Meeting Notes

Project Title	RAF Brize Norton Airspace Change Process
Client	RAF Brize Norton
Purpose of Meeting	Framework Meeting
Date of Meeting	11 th September 2014
Held at	Camm Room, CAA House
Present	[REDACTED], CAA Head Airspace Regulation [REDACTED], CAA [REDACTED], CAA [REDACTED], CAA [REDACTED], A/SATCO RAF Brize Norton [REDACTED], SO3 ATC Plans, RAF Brize Norton [REDACTED], Osprey Consulting [REDACTED], Siluri Integration on behalf of Osprey Consulting
Copies to	RAF Brize Norton internal distribution through Proj O
Classification	Unclassified
Osprey Reference	7751 028
Issue	Issue 1

RAF Brize Norton Airspace Change Proposal

Framework Briefing

Draft Airspace Design

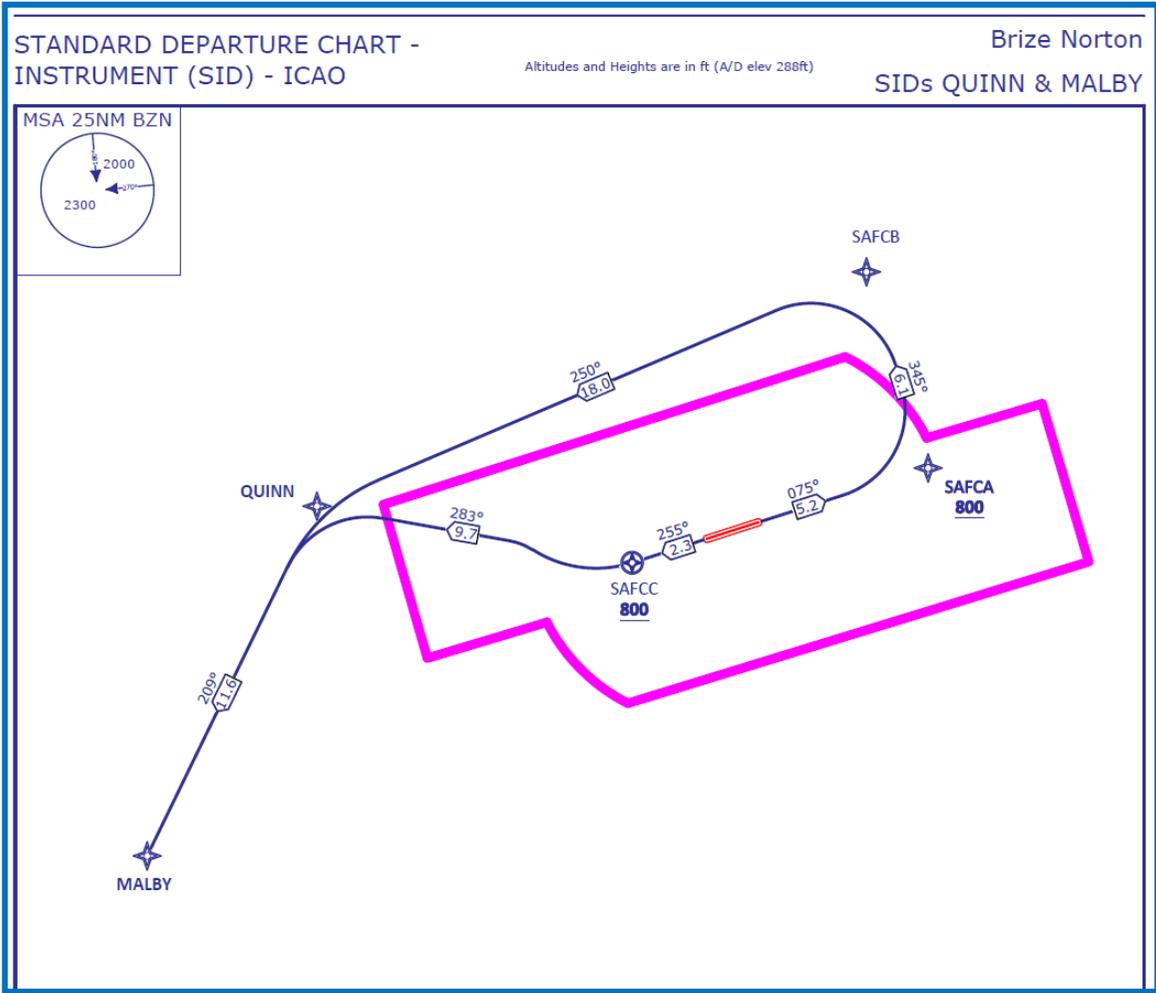
- The initial 'working draft' airspace proposal includes a CTA base level at 1700 ft [Area 2]; this is non-standard and CAA recommended this be amended to either 1500 or 2000 ft. This will be reassessed during stakeholder engagement prior to formal consultation.
- Accepting that the training requirements of BZN ac are different from standard civil airports, the requirement for 3 holds will need to be fully justified.

- **ACTION:** [REDACTED] to gather data on current usage of the BZN instrument hold and the number of CTR overflights.
- Standing agreement CAS joining and exit levels for BZN ac are FL 80 and FL 90 respectively, although on a tactical basis higher levels are regularly allocated. The 'working draft' takes account of these higher levels and has CAS up to FL 125 [Area 5]; this additional CAS will have to be fully justified in the proposal.
